**CONSOLIDATED REPORT Nº 1 ON REQUESTS FOR CLARIFICATION,
CORRECTION, AND/OR EXPANSION ON THE "PROYECTO HIDROELÉCTRICO
ALTO MAIPO" [UPPER MAIPO HYDROELECTRIC PROJECT] ENVIRONMENTAL
IMPACT STUDY**

1. PROJECT DESCRIPTION

Figure 1.
Alfalfal Plant
Monthly Variation in Suspended Sediment in Tailrace Channel Water

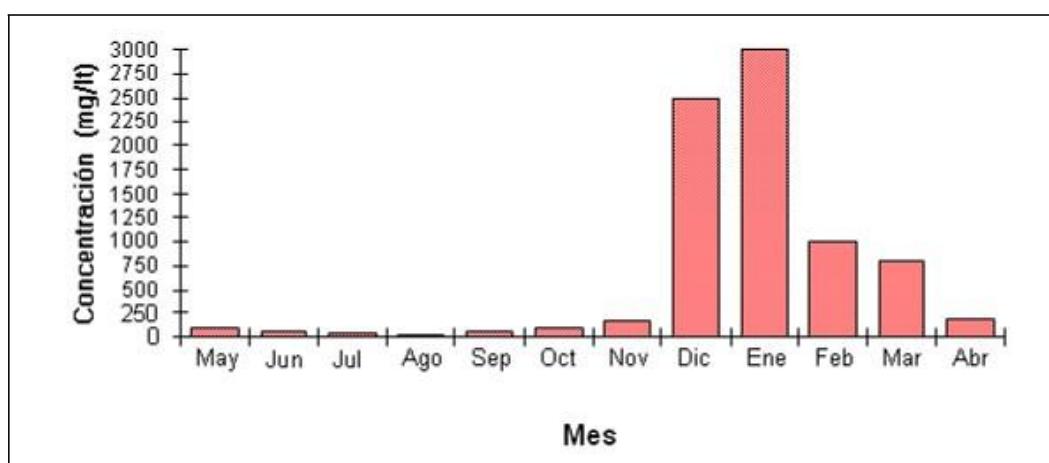
b) Risks identified affecting aquatic organisms and water quality.

It is estimated that the change is sediment load produced by the activities would not be significant, and would fall within normal values for water flowing in Mountain Rivers. In this regard, information available from the 20 years of operations at the Alfalfal Plant shows the following variation in suspended sediment over the course of the year.

Figure 1
Yeso River Siphon

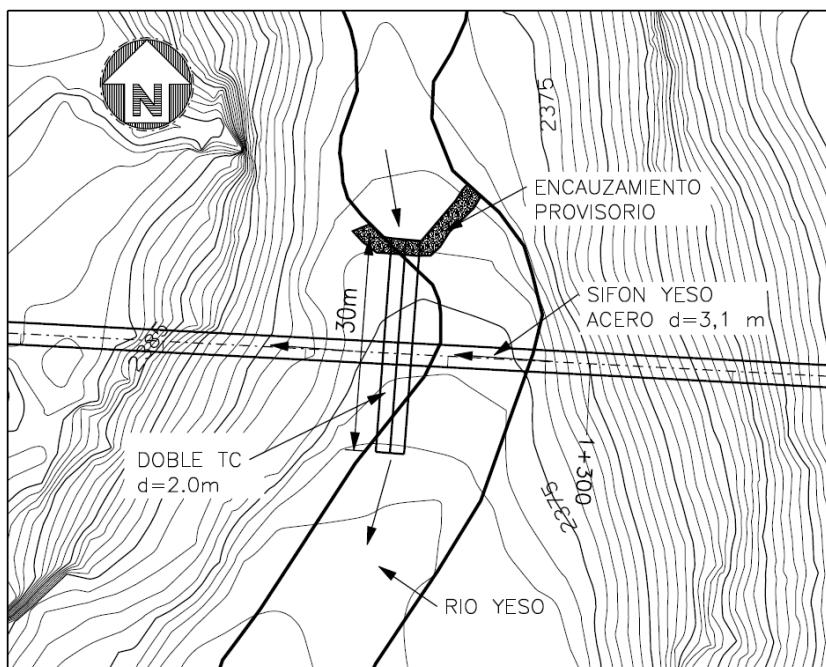
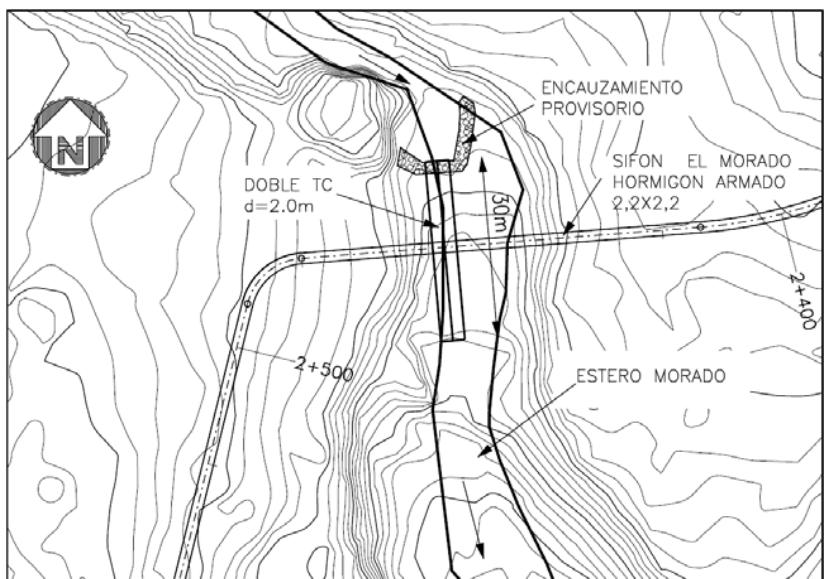
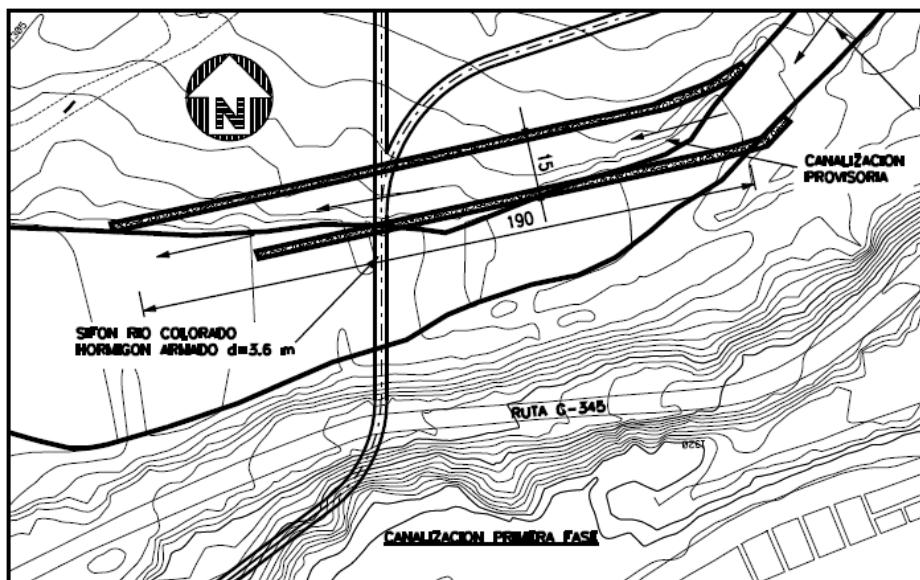
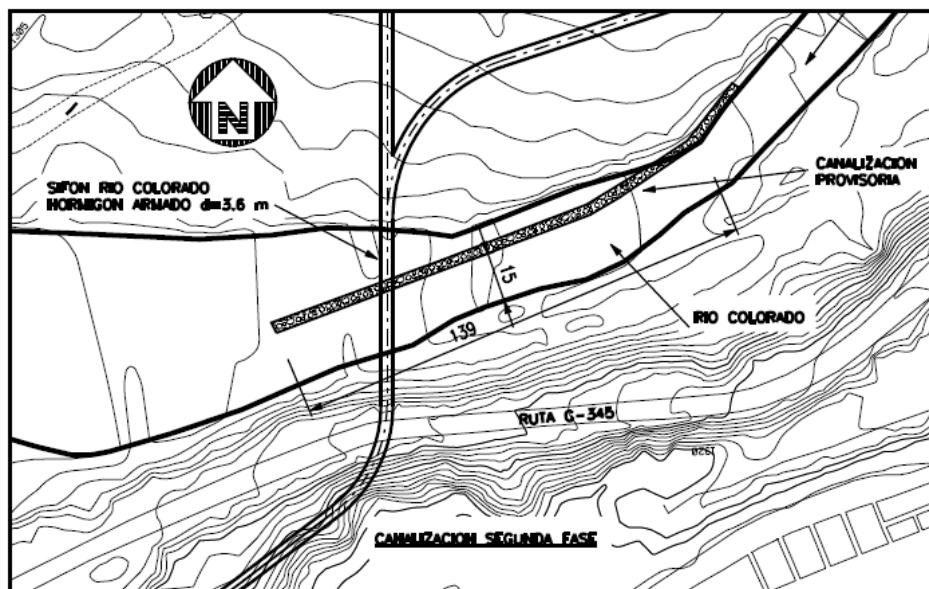
3. Regarding works relating to the temporary diversion of river and stream flow, the Project Owner is requested to clarify the following: a) Estimated duration of diversion; b) Risks identified affecting aquatic organisms and water quality; and c) measures implemented to prevent impact on the ecosystem (aquatic habitat and organisms); d) how the free flowing course of the river and the aquatic organisms that inhabit it will be conserved. In this regard the Project Owner is requested to provide information complementary to that presented in the Environmental Impact Study (EIS).

The project plans for 4 siphons under river courses. These are: the siphon crossing the El Morado stream, downstream of the El Morado Intake; the siphon crossing the Yeso River approximately 2 kilometers downstream of the El Yeso Intake; and two siphons crossing the Colorado River downstream of the Las Lajas forebay. The first two siphons, located in the Volcán and Yeso Sectors, will be constructed by channeling water flow through two meter diameter corrugated metal tubes. One or more tubes will be installed, depending on the flow rate to be channeled. Steel water flow management structures, rocks, and boulders from the river itself will be used to form a temporary parapet, as shown in figures 1 and 2. The length of the corrugated tubes is estimated at 30 m. Once the stream is flowing through the tubes, excavations will be made to construct works relating to the siphon. The siphon section will be constructed on dry land, and water flow will then be reinstated. The design of the siphons includes protective rock fill/riprap on the streambed and banks, designed to support the maximum design flow rate. Once works have been completed on the siphon, water will be returned to the normal watercourse. Areas disrupted by the water diversion will be restored, including pre-existing topsoil and vegetation, using the same types of plants as occur naturally.

The second siphon on the Colorado River will be constructed by means of diversion the river flow through a temporary channel, which will have to be conducted in two phases. Figure 3 shows the first phase, with the river passing through a 15 meter wide channel to the North of the current watercourse. The siphon will then be constructed under the current watercourse. Once this activity has been completed, the river will be re-diverted back into its current course, and the second phase will be channeled as shown in Figure 4. Excess material excavated will be transported to deposits established for this purpose in the project plan.

Figure 5
Las Lajas Forebay

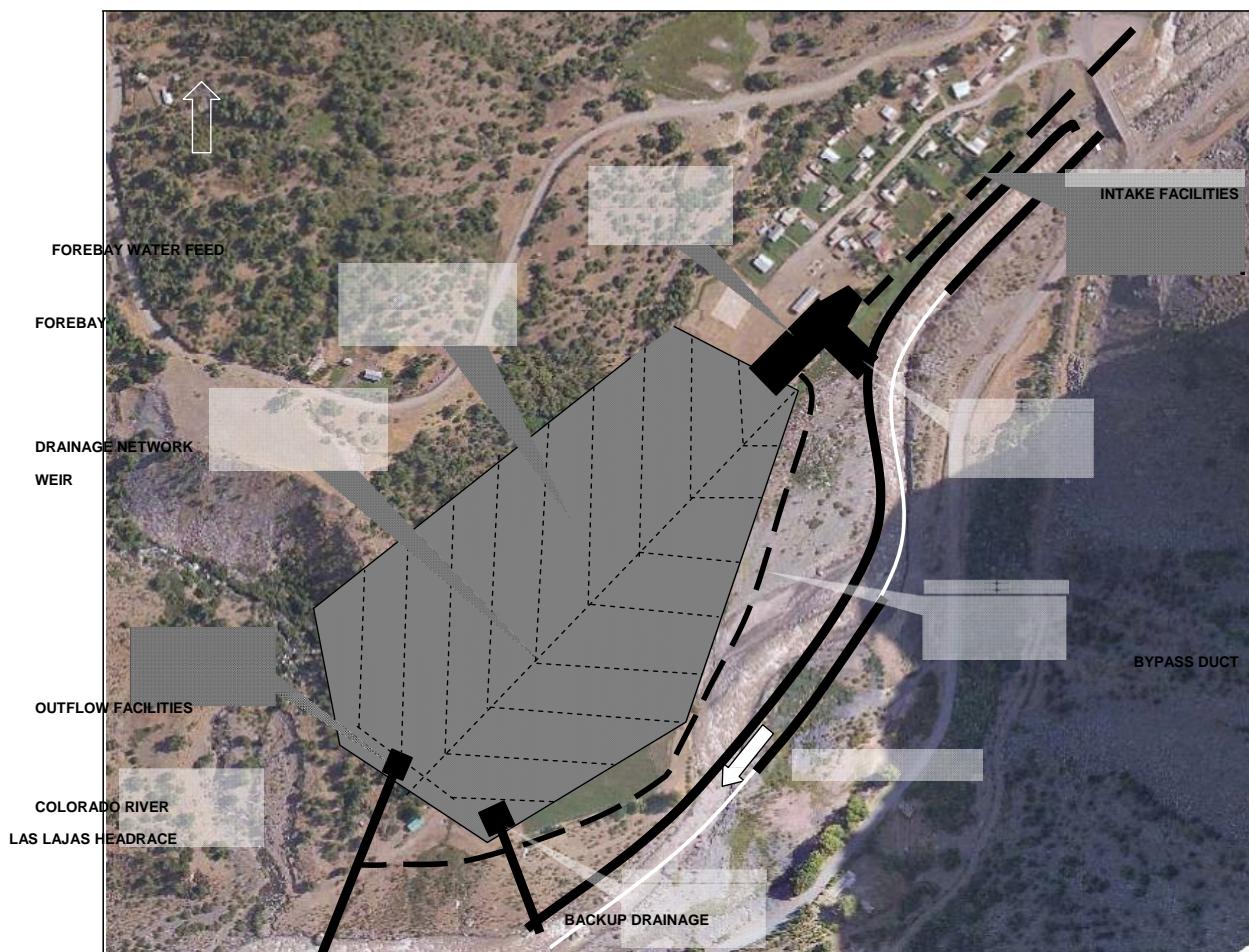
16. *The Project Owner is requested to indicate the technical measures and emergency and/or mitigation plans envisaged for the project, during construction and operation of the Las Lajas Plant forebay. Additionally, a statement is requested with attached analysis regarding the risks of mudslides and/or unusually high flow rates in the forebay area.*

The technical measures planned from the design perspective call for this facility to be sited in an area that, as detailed below, is not at risk of flooding from unusually high flow rates.

The main purpose of the Las Lajas Plant forebay is to stabilize the plant's hydraulic head. Additionally, it serves a secondary purpose of maintaining a sufficient volume available to permit compensation for natural sudden increases or drops in flow rate caused by special operations at the plants, such as start-up or service outages. The necessary volume is reached at elevations between 1318 and 1323 masl. The parapet of the forebay walls will be built up to an elevation of 1325 masl.

Figure 1 shows the plant layout of the forebay and associated facilities.

Figure 8
PHAM Water Abstraction Installations in the Yeso River Sector

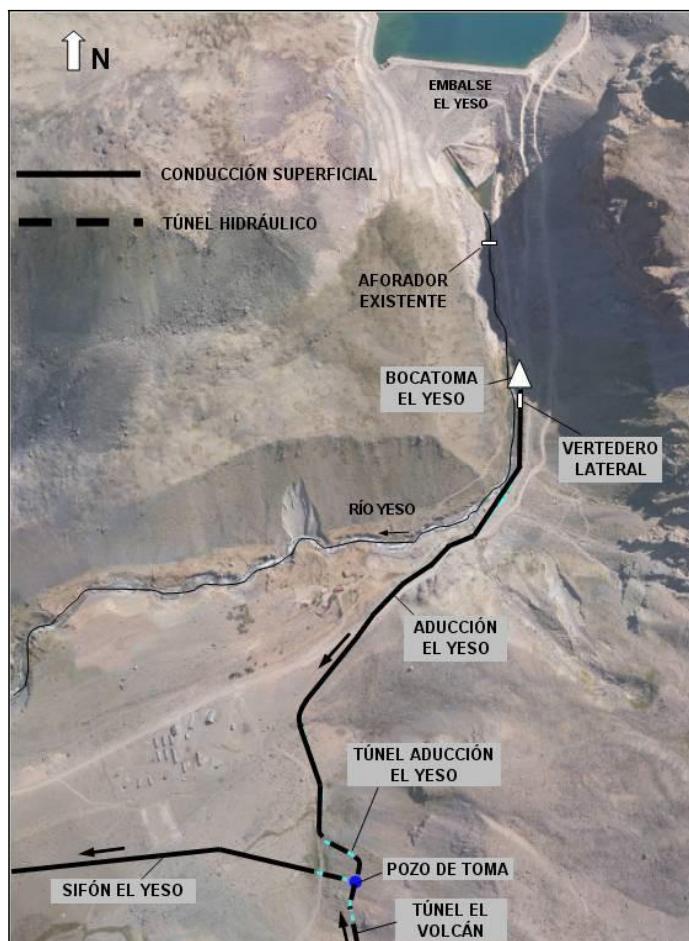
24. *With regard to water abstraction in the Yeso River Valley, please clarify whether plans call for the intervention of any discharge or other works in the system of the El Yeso Reservoir, or the drinking water system owned by the company Aguas Andinas.*

As shown in the following figure, water abstraction facilities planned under the PHAM in the Yeso River are located approximately 700 m downstream of the reservoir, and therefore cannot interfere in any way with its operation.
